Bureau of Environmental Health

RE: Percolation Test Results, Allnut Farms Estates, Section 4, Lot 21, A559759

PERC CERTIFICATION PLAT
LOT 21 ALLNUTT FARMS ESTATES

Enclosures (2): Percolation Test Field Worksheets

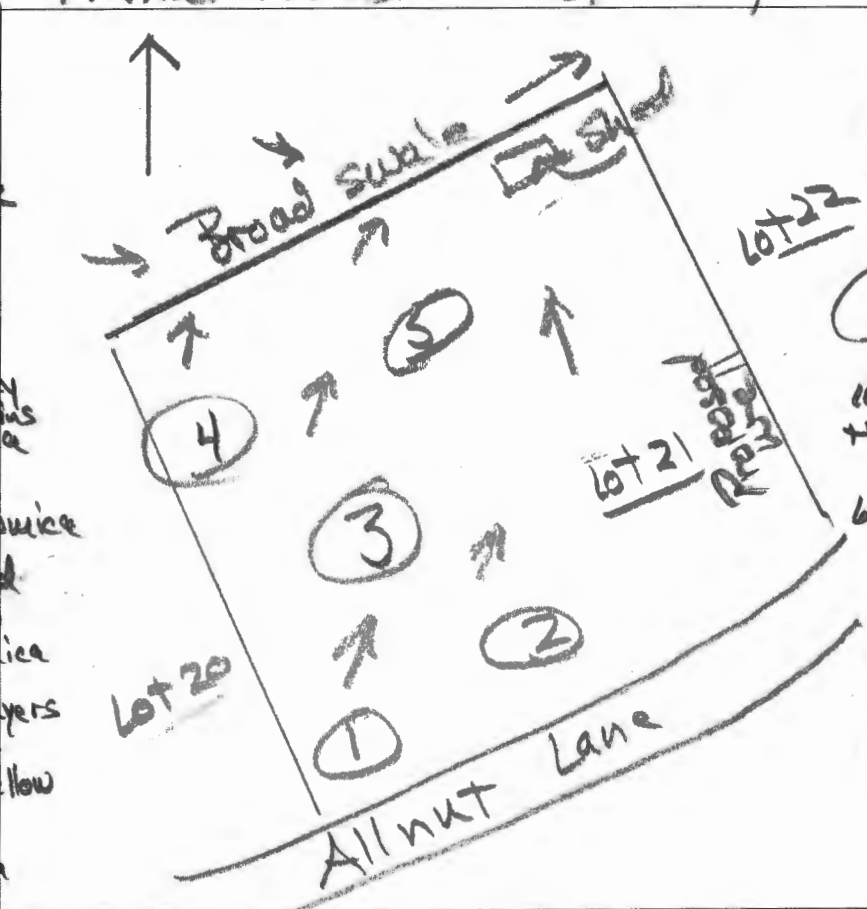
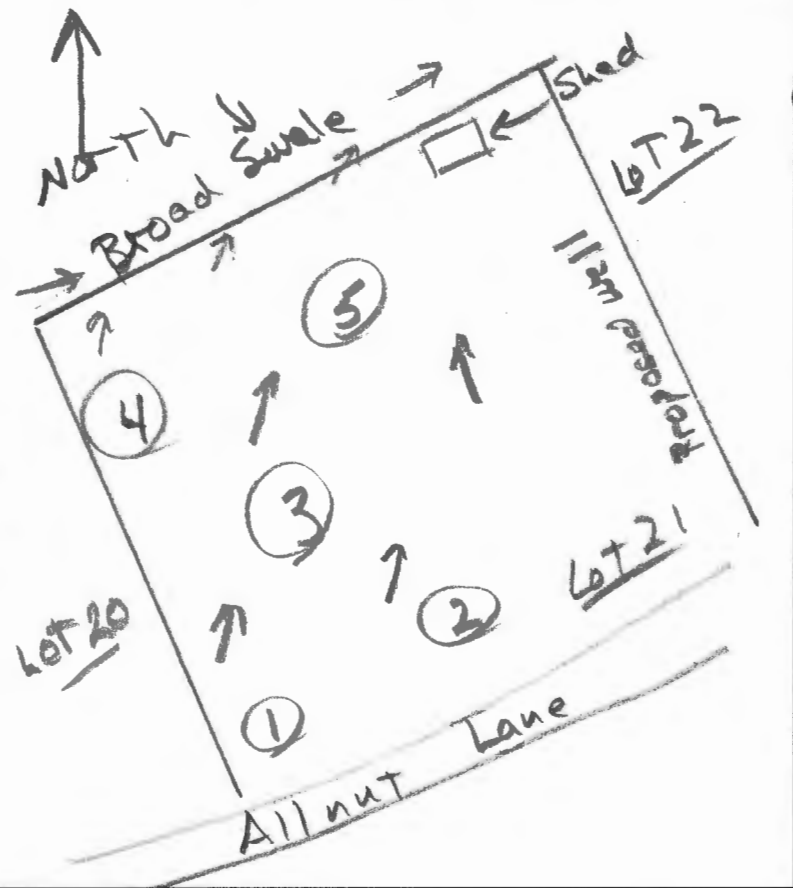
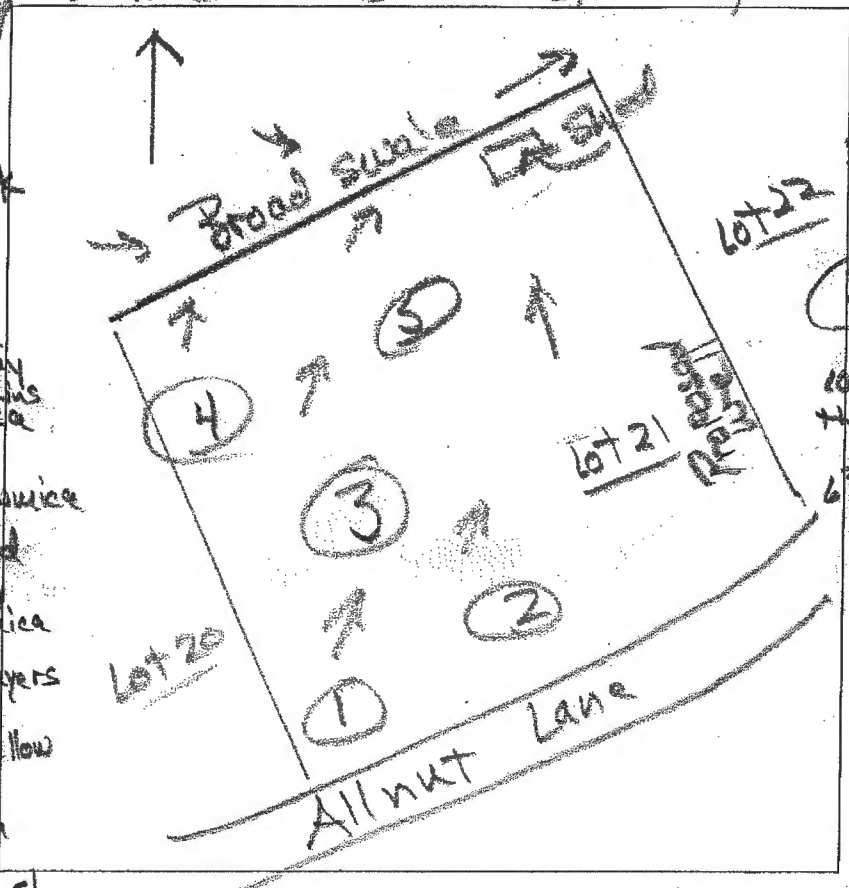
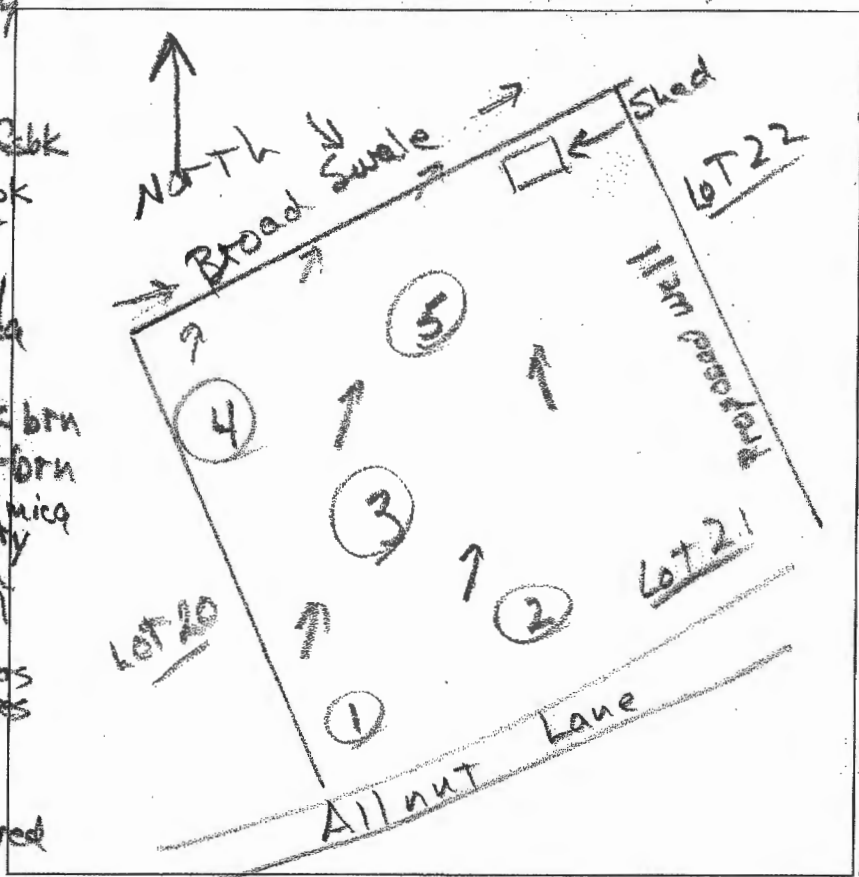
Percolation tests pits were dug at five staked locations (1 thru 5) within a proposed private sewage area. Test locations 1, 2, and 3 PASS with percolation rates of 3 to 5 minutes per inch generally below 3.4 to 4.3 feet depth. The usable soil profiles at locations 4 and 5 were truncated by apparent water table at 6 feet depth at location 4, and by rock greater than 50 percent at 6 feet depth at location 5. Percolation tests at locations 4 and 5 were conducted at 2 feet depth. Very little to no infiltration was observed during prewet periods of 60 minutes and 30 minutes at locations 4 and 5, respectively; locations 4 and 5 FAIL. Only about 6400 sq.ft. of the proposed private sewage area is represented by test locations 1, 2 and 3.
